Site: Land to the east of Tilletts Lane, Warnham
Prepared by: Chris Gray
Approved by: Jason Morgans
Date: 8 October 2025

1.0 Introduction

2.0 Resolving LLFA Objection to Horsham District Council Planning Application Number DC/25/1155

LLFA Consultation Letter Referenced DC/25/1155 and Dated 11 September 2025 for
Horsham District Council Planning Application Number DC/25/1155

Figure 2.1 - Robinsgreen and surrounding land south of the access road and Existing Topographical Information converted to 0.02m and 0.10m contours and arrows

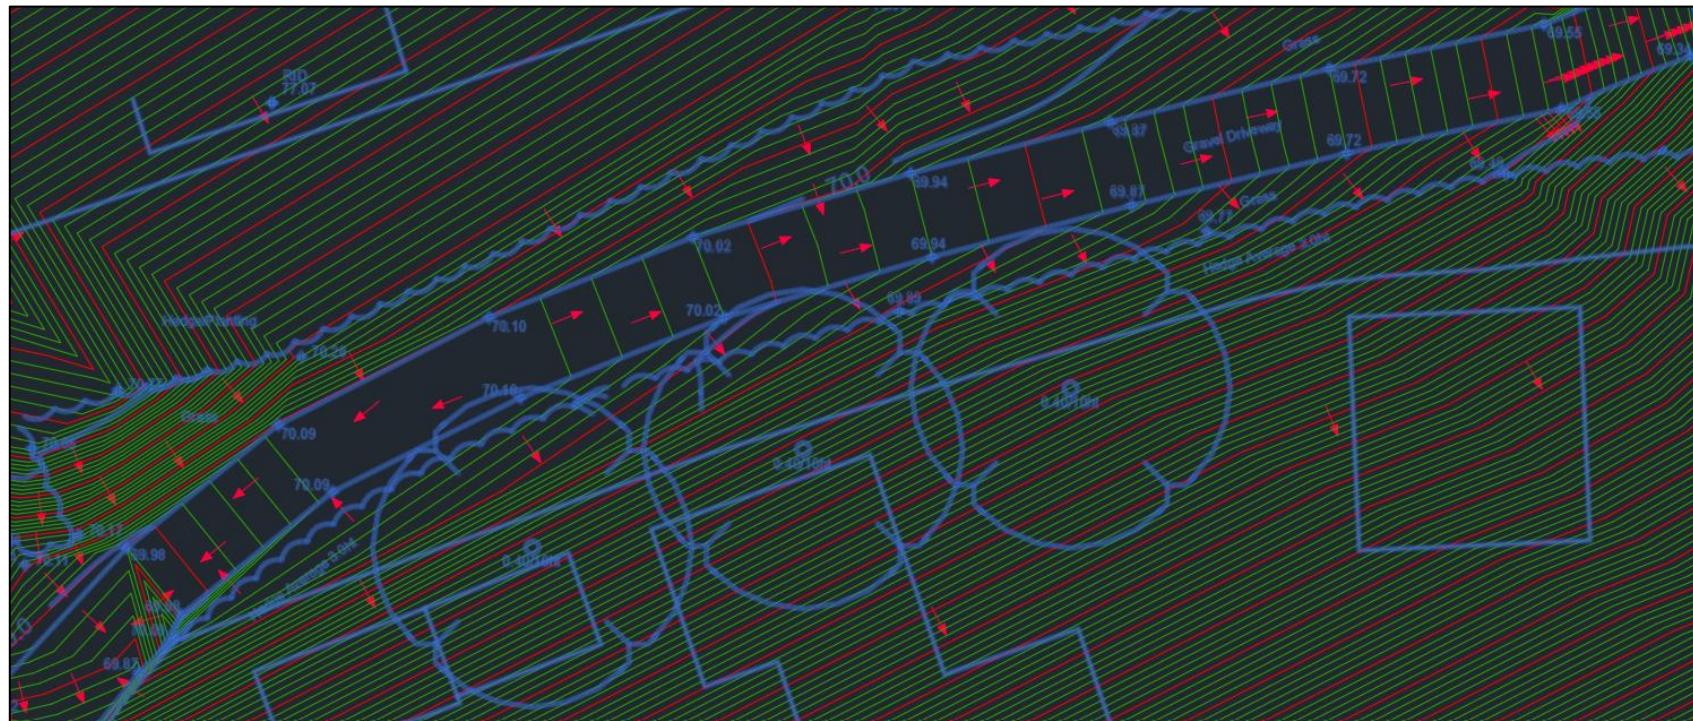
1) The exceedance routes appear to affect both existing properties and areas outside the red line boundary (in particular Robinsgreen and surrounding land south of the access road) and potentially plots 47 and 50. Please can the exceedance routes be checked and clarification provided for these areas in particular. It may be of benefit to overlay the exceedance plan over topographic data to demonstrate the exceedance flows will not impact these area.

2.2 [Figures 2.1](#) and [2.2](#) show Robinsgreen and the surrounding land south of the access road; Existing Topographical Information; and the Proposed Levels Design converted to 0.02m and 0.10m contours and arrows. The existing overall slope is towards the south southeast, with the existing gravel driveway sloping both towards the southwest and east northeast. The proposed access road crossfall slopes towards the southeast. The arrows in [Figures 2.1](#) and [2.2](#) indicate that exceedance from the existing gravel driveway and upgradient land will flow towards Robinsgreen and the surrounding land south of the access road, whereas exceedance from the proposed access road and upgradient land will be contained by the 125mm access road kerb and routed towards the southeast where double gullies are proposed at the proposed site access. With reference to the Drainage Strategy submitted as part of the planning application, the double gullies will drain to Basin 3 via Proposed Manhole S47.

Figure 2.7 - Existing Topographical Information converted to 0.02m and 0.10m contours and arrows that show the existing overall slope is not towards the existing ordinary watercourse along the western site boundary of the site

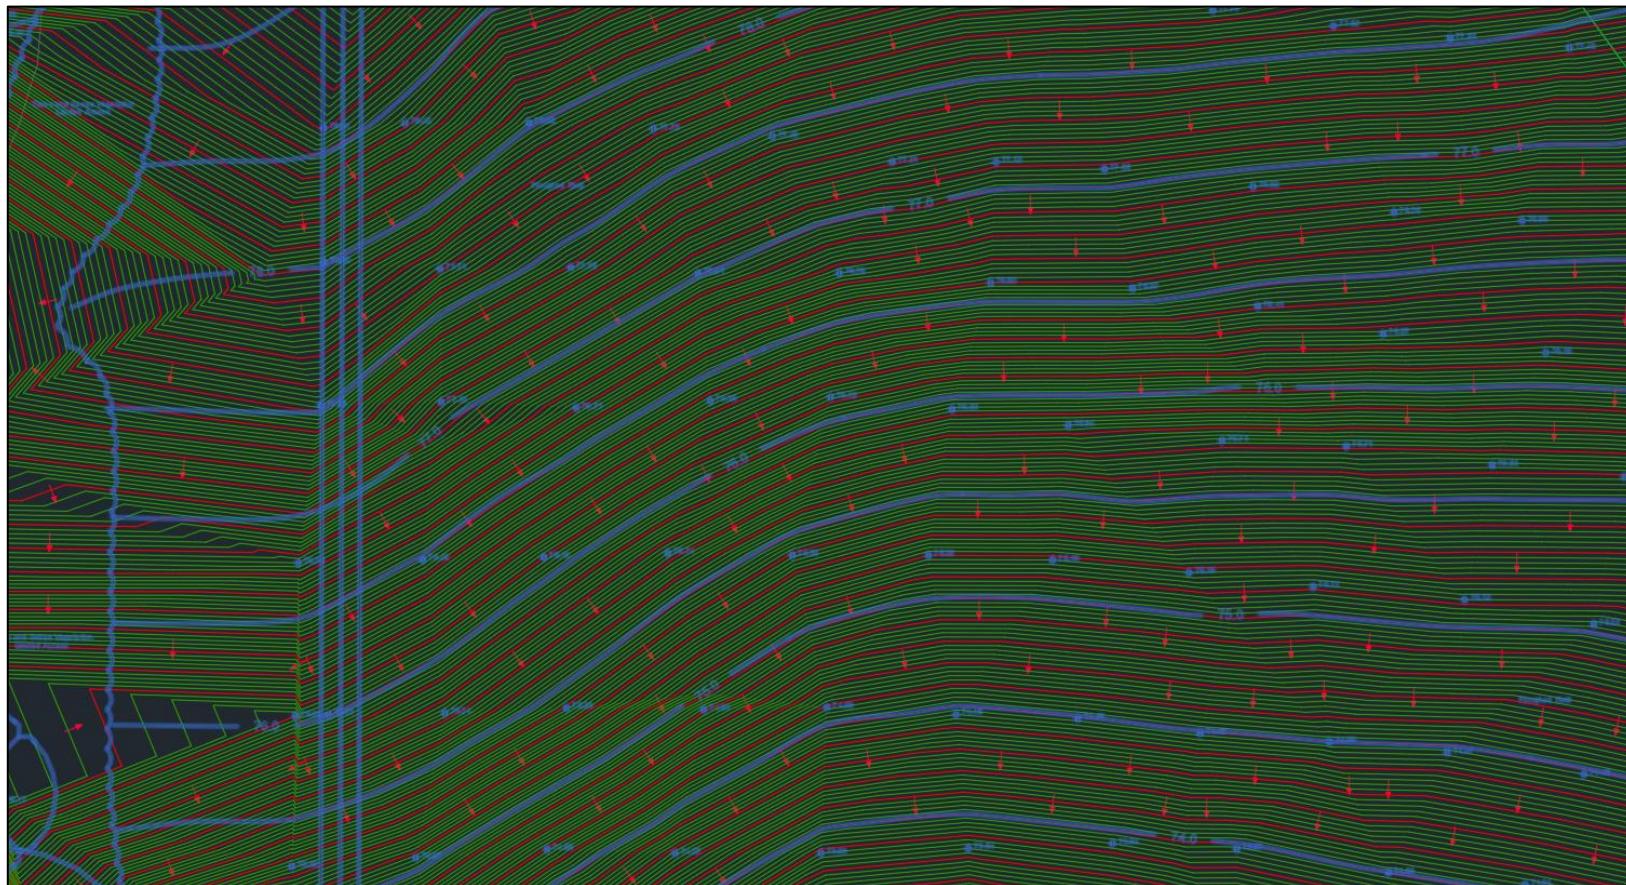
4) It is noted that there is only one discharge point within the site, however the evidence provided shows there is more than one catchment within the site. The surface water drainage system will need to mimic the natural drainage of the site, for example it is unclear why there is not a direct outfall from basin 1 to the adjacent watercourse. This could increase flood risk elsewhere as the distribution of surface water runoff will not be as existing, rather concentrated in one location. Please can this be reviewed and clarified.

2.12 **Figures 2.7 to 2.9** shows the Existing Topographical Information converted to 0.02m and 0.10m contours and arrows close to the western boundary of the site. The existing overall slope is towards the south to an existing ordinary watercourse that flows east at the southwest corner of the site, rather than the existing ordinary watercourse along the western site boundary of the site. Please see updated Motion drawing number 2404044-0500-P07 [Drainage Strategy] in **Appendix C** that shows the bed and bank levels for both watercourses.
